***Mealstream Series 5 CTM3 208v 60Hz
FCC Approval***

Additional Information

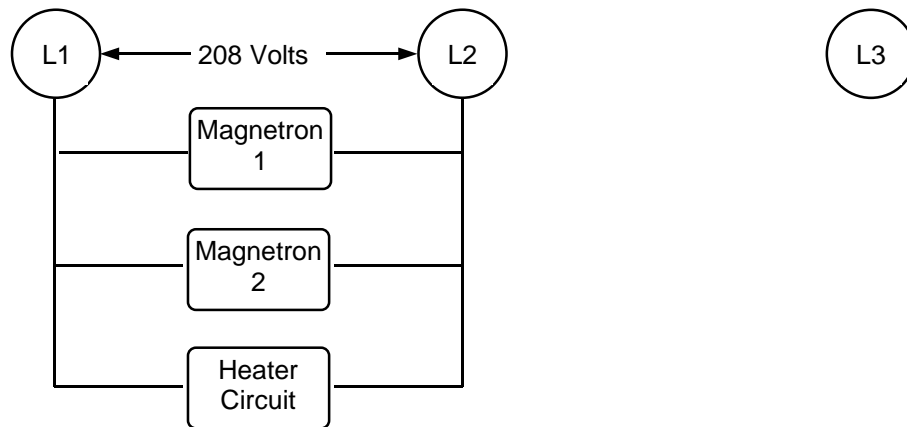
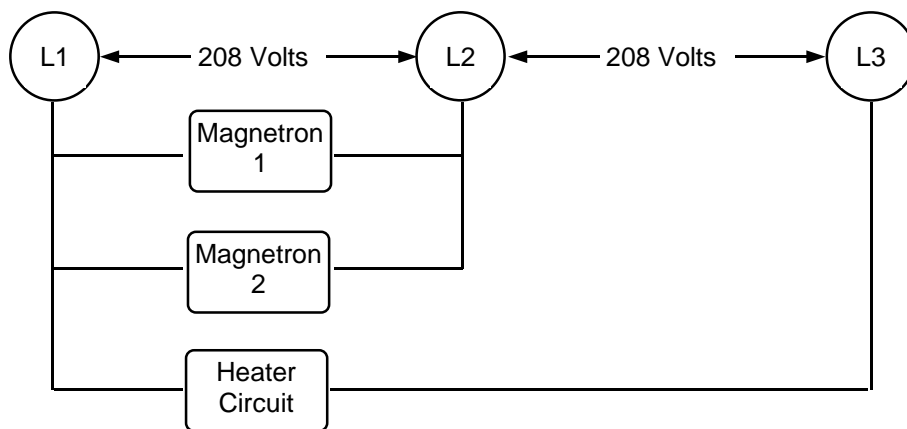
A small modification can be made to the 208v 60 Hz unit to enable the units to run on a three phase supply.

In single phase both the magnetrons and the heater circuit are run on the same phase.

In three phase the heater is run on the third phase alone. This is done by removing a link to the terminal block.

Please note that this modification will take place when the oven is in production.
